AMENDMENT OF SOLICITATION/MODIFICATION OF CONTRACT				1. CONTI	RACT ID CODE	PAGE OF PAGES 1 of 4
2. AMENDMENT/MODIFICATION NO. 0002	3. EFFECTIVE DATE June 30, 2000	4. REQUISITION/I	PURCHASE	E REQ.NO.	5. PROJECT NO). (If applicable)

This amendment is issued to revise a response to a previously answered RFP question and revise the RFP as indicated below:

Fee for Schedule Acceleration

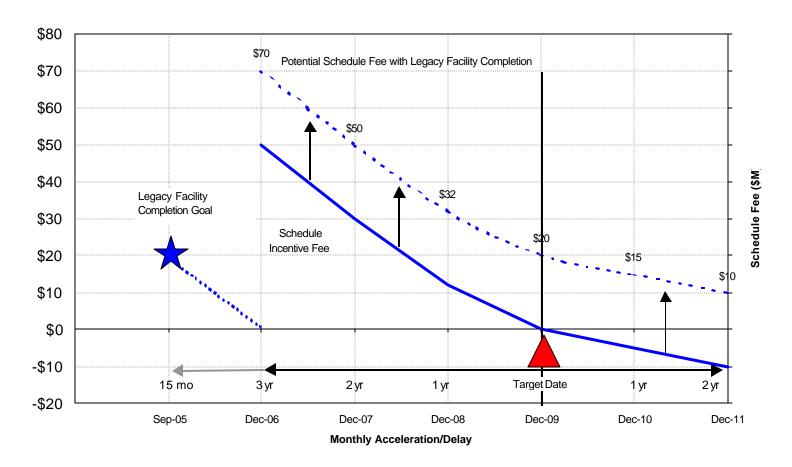
C. Section B.6, "CHART II, SCHEDULE INCENTIVE," is deleted and replaced with the following revised chart:
